GM SERVICE AND PARTS OPERATIONS  
DCS2042  
URGENT - DISTRIBUTE IMMEDIATELY

Subject: 07273 - Safety Recall  
Front Door Glass Shatter – Replace Bolts

Models: 2003-2004 Pontiac Vibe Equipped with Power Windows

**SUBJECT:** Front Door Glass Shatter – Replace Bolts

2092916

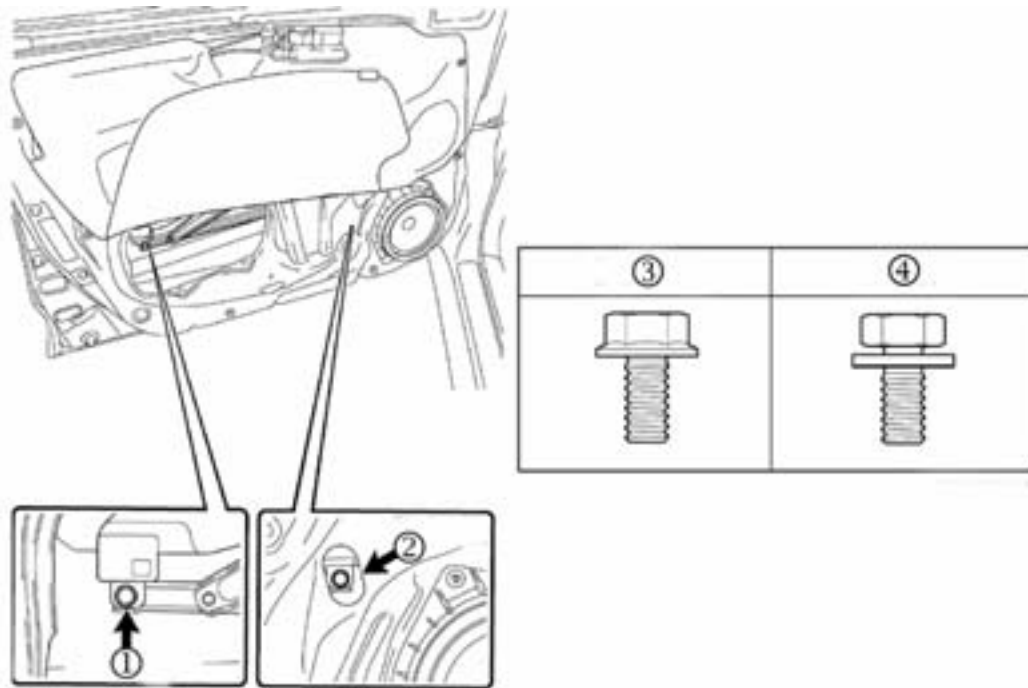
(3) First Design Bolt  
(4) Second Design Bolt

- 13. Remove the first design bolt (1), which is securing the front door glass, and install a second design bolt (4). Finger-tighten.
- 14. Remove the first design bolt (2), which is securing the front door glass, and install a second design bolt (4). Finger-tighten.
- 15. Tighten both bolts.

Tighten to 9 N·m (80 lb in).
